# M5 West widening

Submissions and Preferred Project Report

MAIN VOLUME / MAY 2011

Figure 4.1(a) Preferred project – Camden Valley Way to Moorebank Avenue

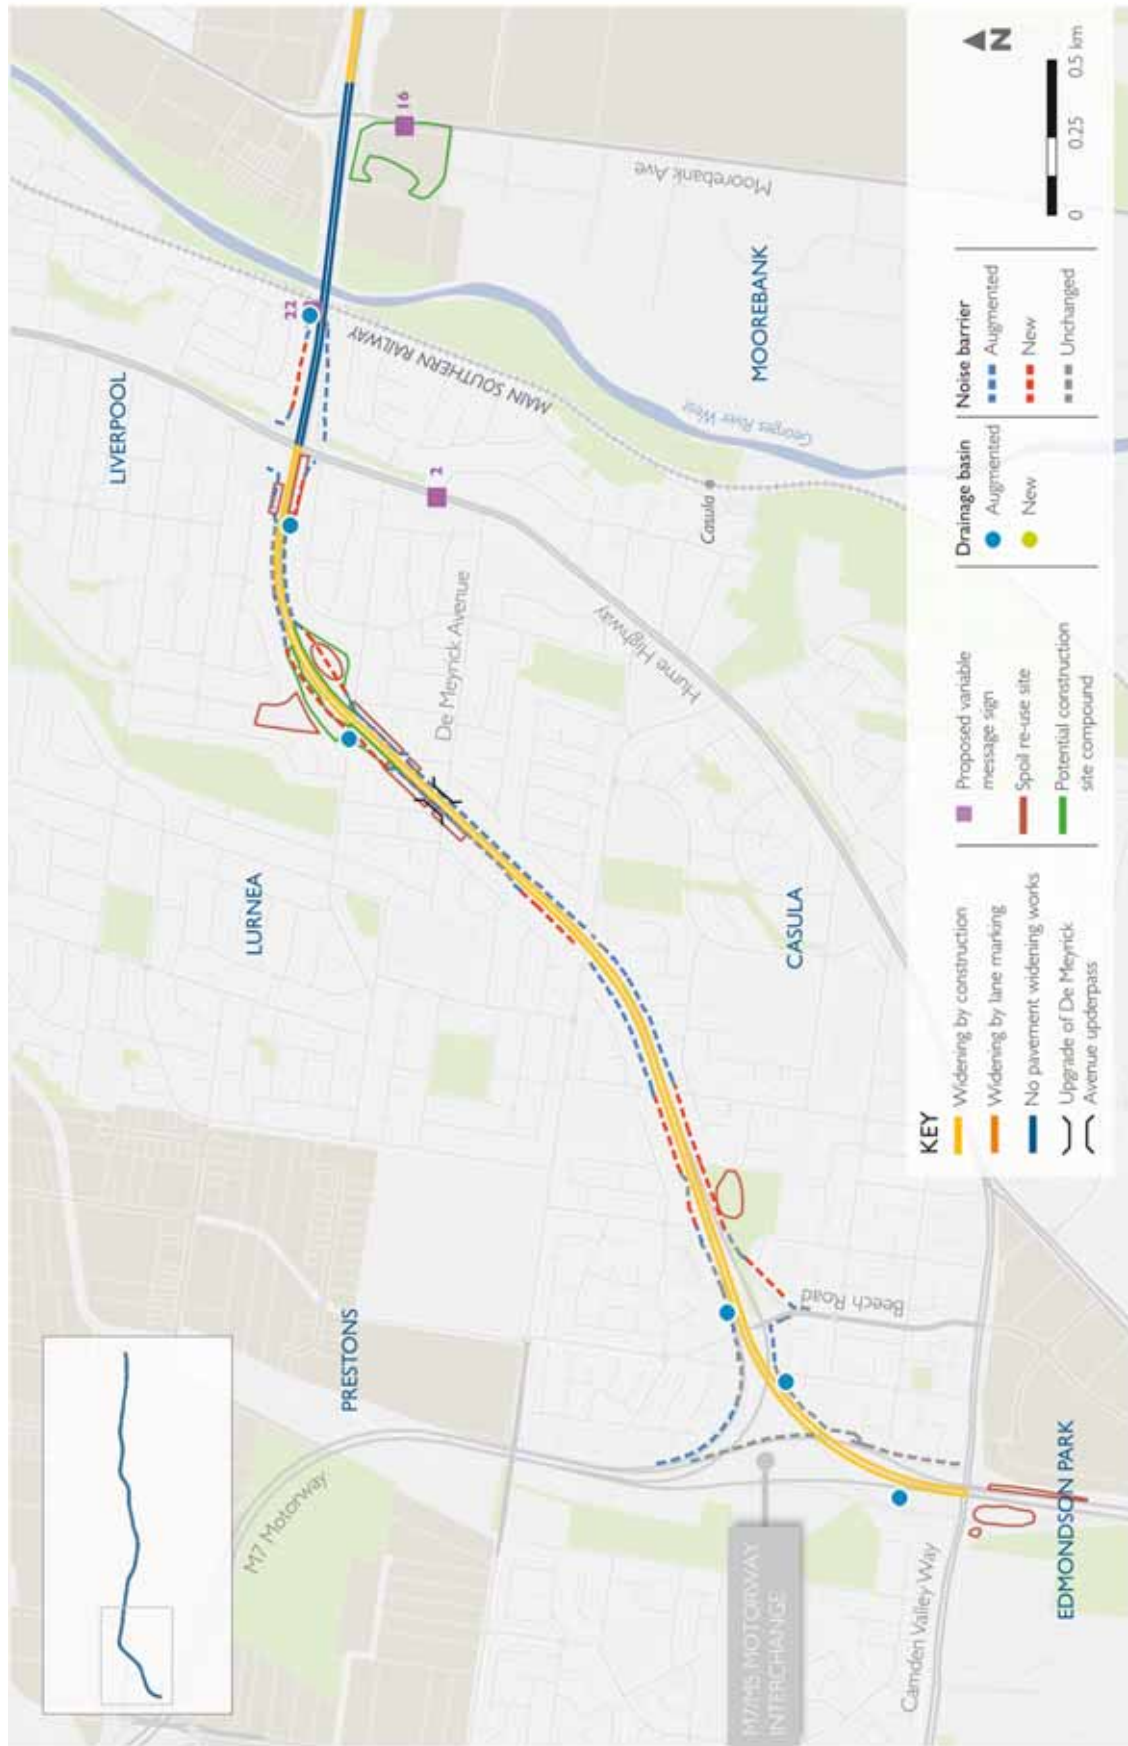
3. As a result of the additional noise investigations, the RTA now proposes new and augmented noise walls at the Hume Highway interchange. Figure 4.1 shows the location of new or augmented noise walls (refer also Appendix C).

Figure 4.1 (a)-(d) illustrates the changes that have been made since the public exhibition of the environmental assessment. This is the preferred project.

The approximate location of the drainage basins that were not originally identified in the environmental assessment are shown in Figure 4.1.

The environmental assessment described the localities of variable message signs and the general area was represented on figures within the environmental assessment. However, it should be noted that the localities of some of the variable message signs as shown in the environmental assessment figures were incorrect. However, environmental assessment of the variable message signs, and community consultation, was undertaken on the correct localities. The variable message sign localities are confirmed in Figure 4.1.

An additional spoil reuse site for the project has been identified to the north of Graham Avenue and is shown in Figure 4.1.
